Staff Report

Site Plan Review

SP-22-19

December 27, 2019

TITLE: BEST POTS ELEVATIONS

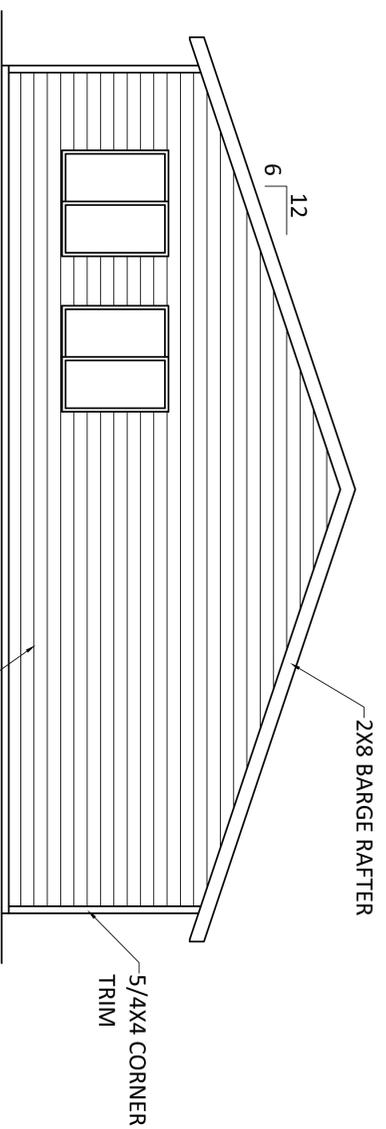
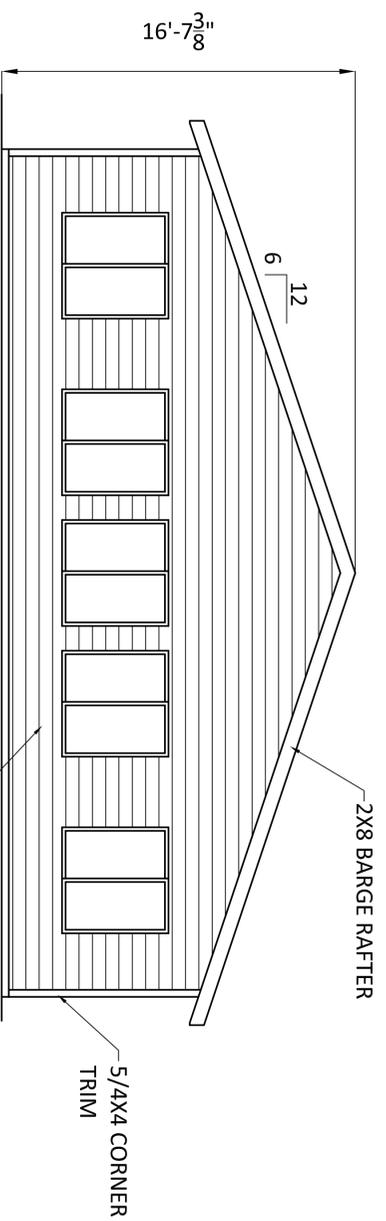
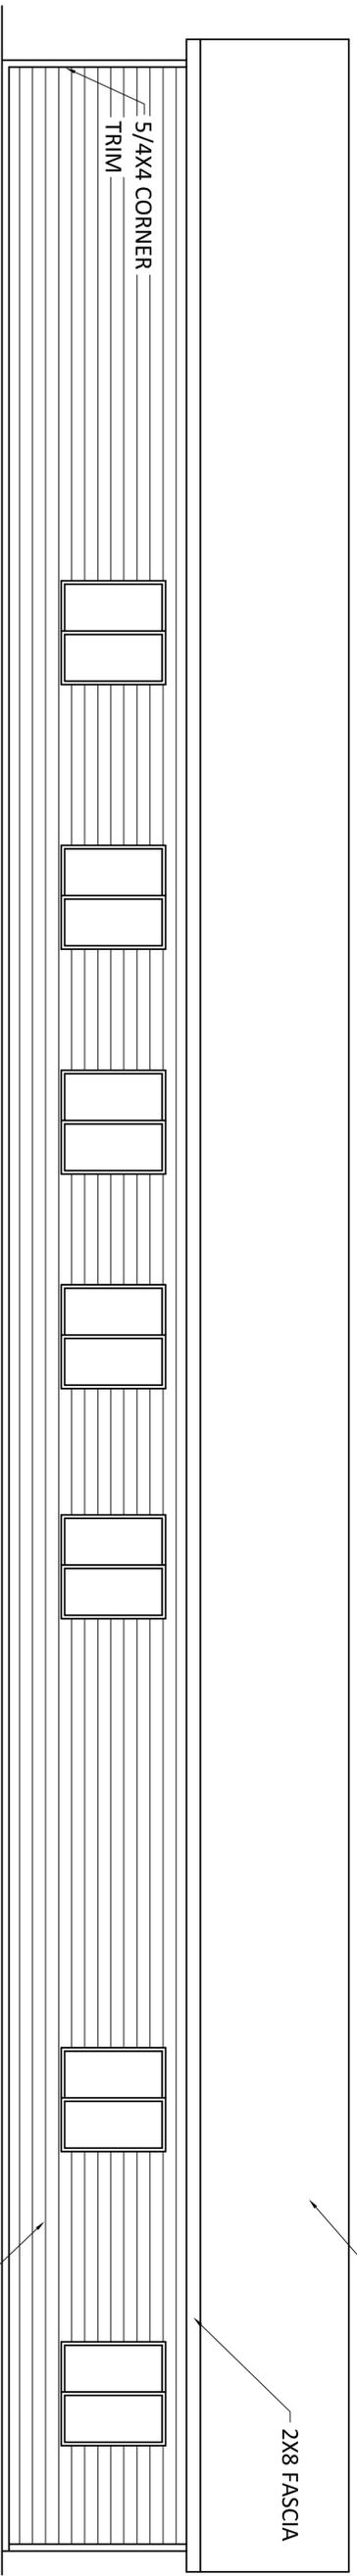
- 5.5 Building Height. According to the applicant's elevation drawings (Attachment C), the proposed building height is approximately 16 feet 7 inches. There is no maximum height standard for the LI district. This standard is not applicable.
